Subject: Peach Bottom Atomic Power Station, Units 2 and 3  
Response to NRC Request For Additional Information (RAI)  
Regarding Generic Letter 96-06.

"PECO Energy Response to the  
NRC's Request for Additional Information  
Dated 05/28/98 (PBAPS)  
Regarding Generic Letter 96-06"

Figure 1 – PBAPS Drywell Cooling System (typical of 2 loops)

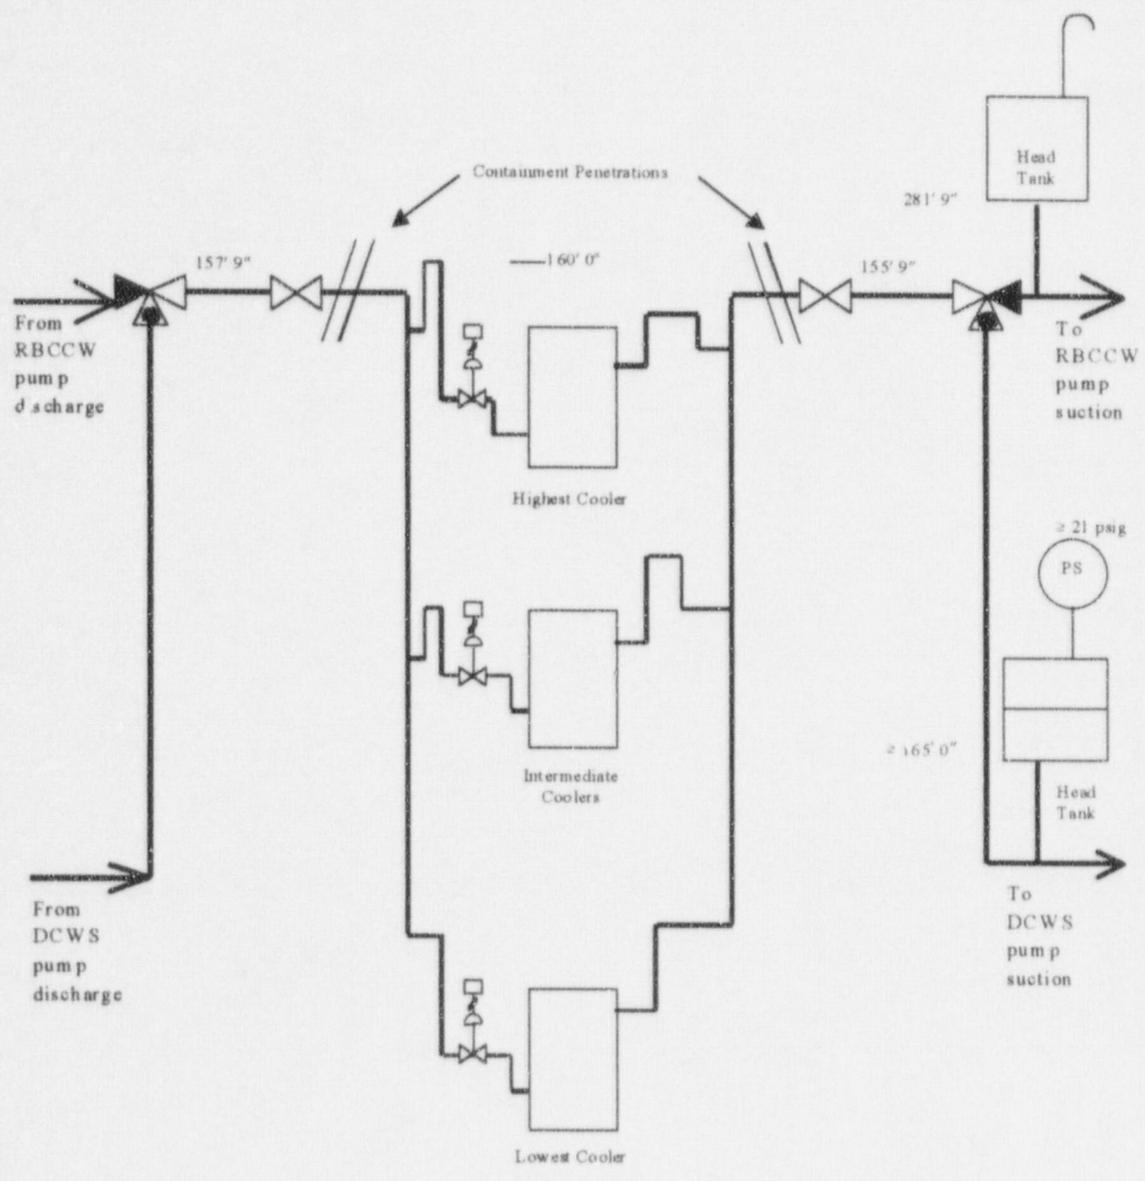
6. *Provide a simplified diagram of the affected systems, showing major components, active components, relative elevations, lengths of piping runs, and the location of any orifices and flow restrictions.*

See Figure 1 above for a simplified diagram of the affected systems at PBAPS. Lengths of pipe runs are not indicated, since the lengths of runs are not significant in cases where waterhammer and two-phase flow are not credible.
